HISTORIC PRESERVATION COMMISSION AGENDA ITEM EXECUTIVE SUMMARY Agenda Item COA: 305 W. Main St. (doors) Title/Address: Replace one door; brick over one door **Proposal: Petitioner:** Oleg Shulzhenko SINCE 1834 Please check appropriate box (x) **PUBLIC HEARING MEETING** X 7/15/15 **AGENDA ITEM CATEGORY:** X Certificate of Appropriateness (COA) Façade Improvement Plan **Preliminary Review** Landmark/District Designation Discussion Item **Commission Business ATTACHMENTS:** Drawing of new door Photos of building Email & photo from owner Architectural Survey page **EXECUTIVE SUMMARY:**

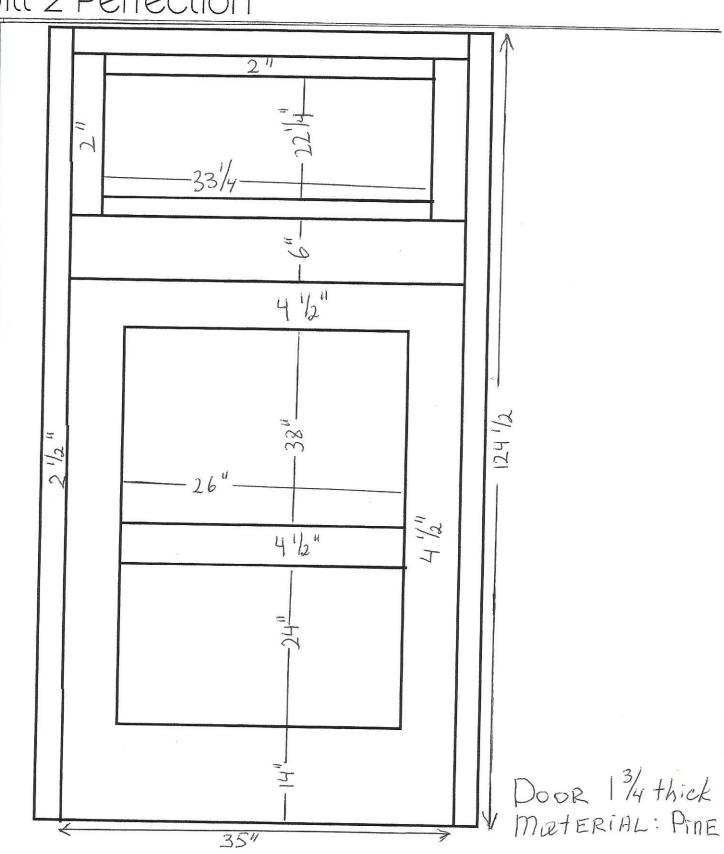
The center door on the front façade has been removed and bricked over.

The easternmost door has been replaced with a wood door, in a similar style as the existing main entrance door. The window above the door has also been replaced.

Provide feedback and recommendations on approval of the COA.
